E C O L O G I C A L R E V I E W

Rockefeller Refuge Gulf Shoreline Stabilization

(State No. ME-18)

September 20, 2005

Figure 2. Design layout for test sections (Shiner Moseley and Associates, Inc. 2005).

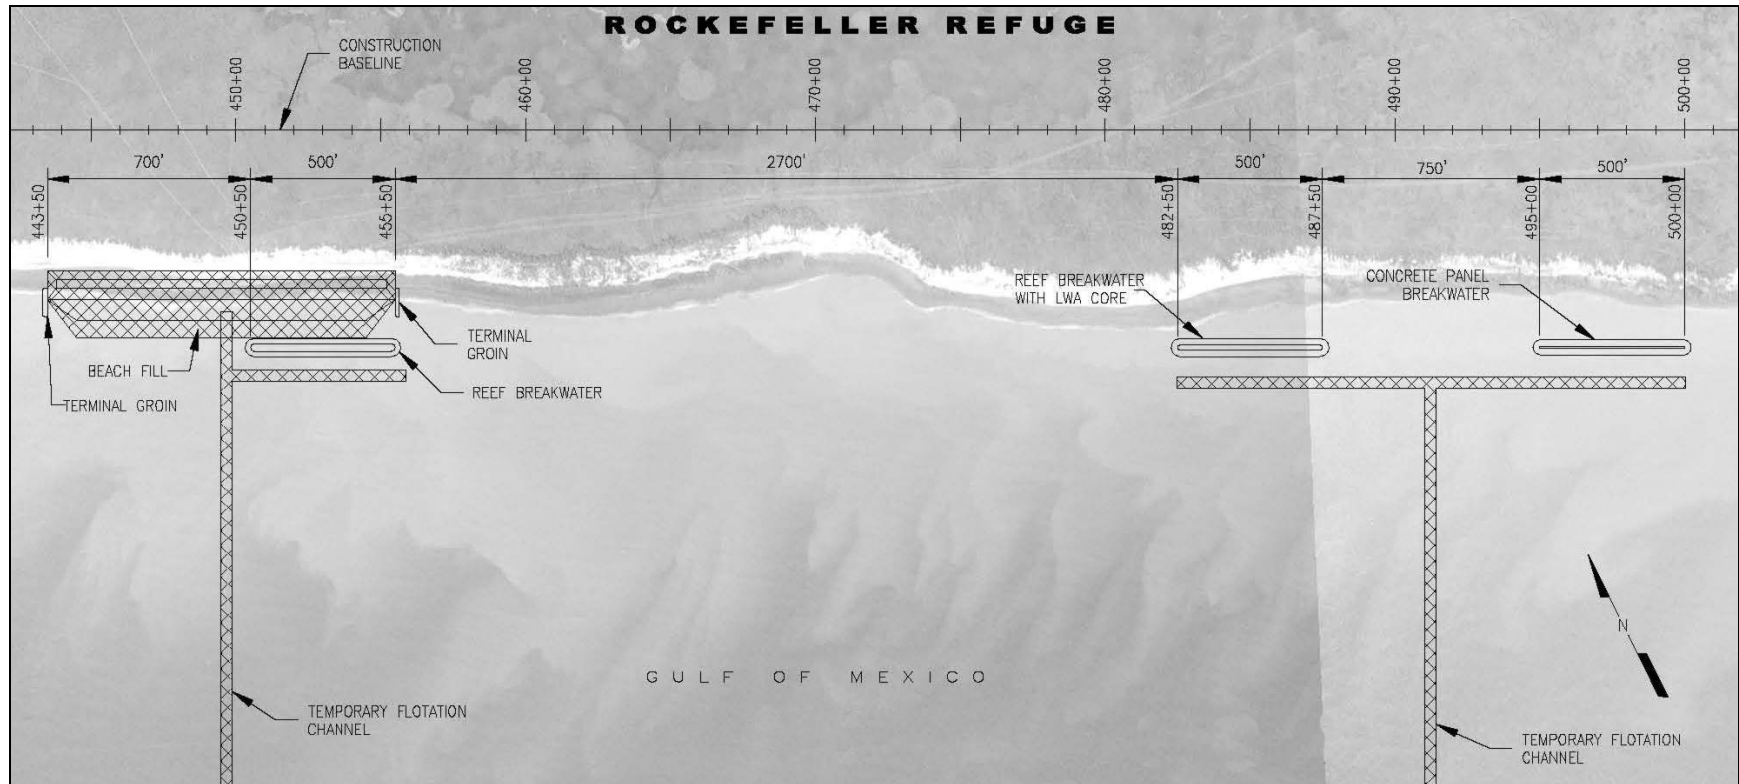
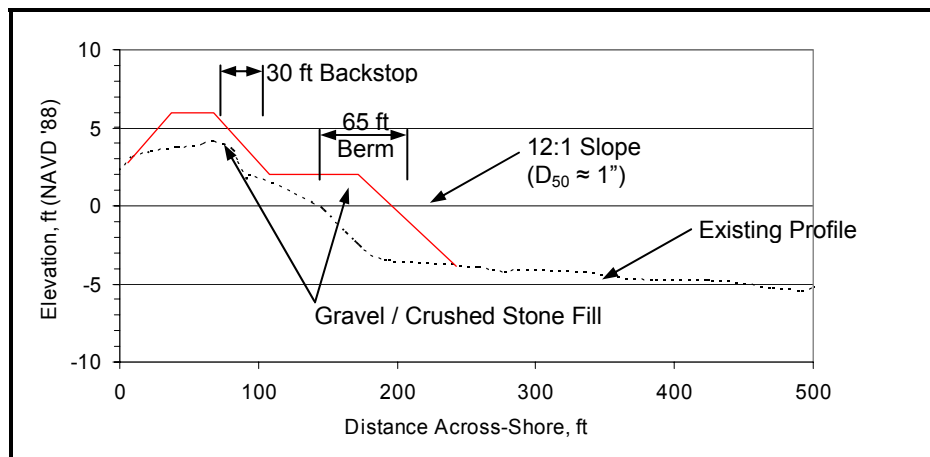
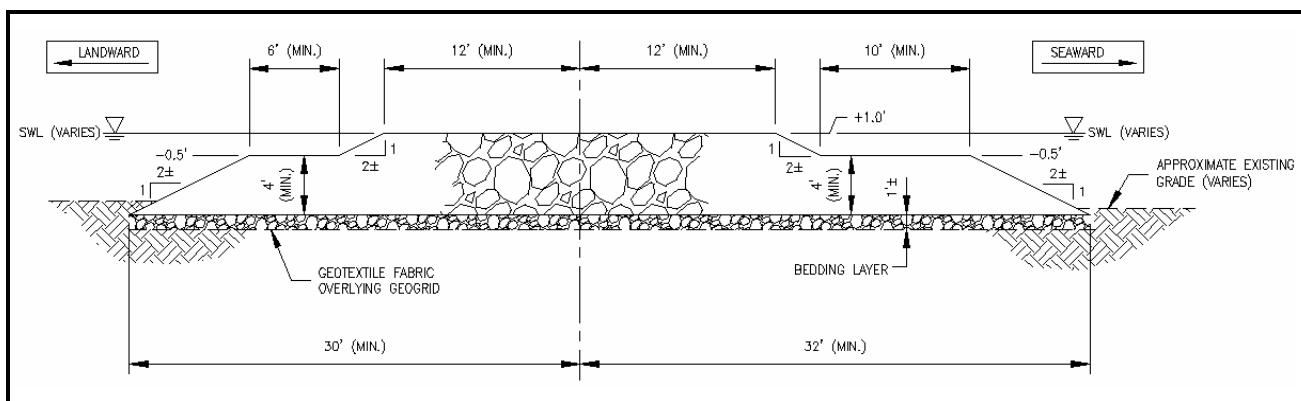
The design and layout of the test sections appear to be acceptable. In the Lake Salvador Shore Protection Demonstration project, the treatments were not randomly placed along the shoreline, and their close proximity to one another resulted in noticeable treatment interactions. As a result, statistical testing of the data was not possible and definitive conclusions regarding the treatments' influence on shoreline erosion rates could not be drawn. For the Rockefeller Refuge Gulf Shoreline Stabilization project test sections reviewed in this document, Shiner Moseley and Associates, Inc. (2005) considered wave diffraction for spacing of the breakwater alternatives, and estimated that a breakwater spacing that exceeds five times the wavelength will allow the breakwaters to function independently of each other. In addition, the excessive distance from the shoreline that led to the reduced effectiveness on past projects has been addressed in this project. Consideration was given to knowledge that to prevent any potential wave regeneration between the breakwater and the shoreline, a fetch of 200 feet or less would effectively limit the erosive waves that could harm an un-vegetated shoreline (Shiner Moseley and Associates, Inc. 2005).

Random variability in local geological conditions may affect the test results more than would any differences among the competing designs. Without replication (building more than one of each design) the relative effectiveness of the designs is essentially unknowable. Monitoring a control area, although worthwhile, does not improve this data gap. Recent aerial surveys show that shoreline erosion rates vary by more than fifteen feet per year over short distances in the vicinity of the test area (Shiner Moseley and Associates, Inc. 2005). The geotechnical survey reports spatial variability in the mechanical properties of the soils that may affect subsidence more than would the differences in breakwater construction (Shiner Moseley and Associates, Inc. 2005). Therefore, limitations exist in interpreting the results of data obtained from monitoring the test sections of this endeavor.
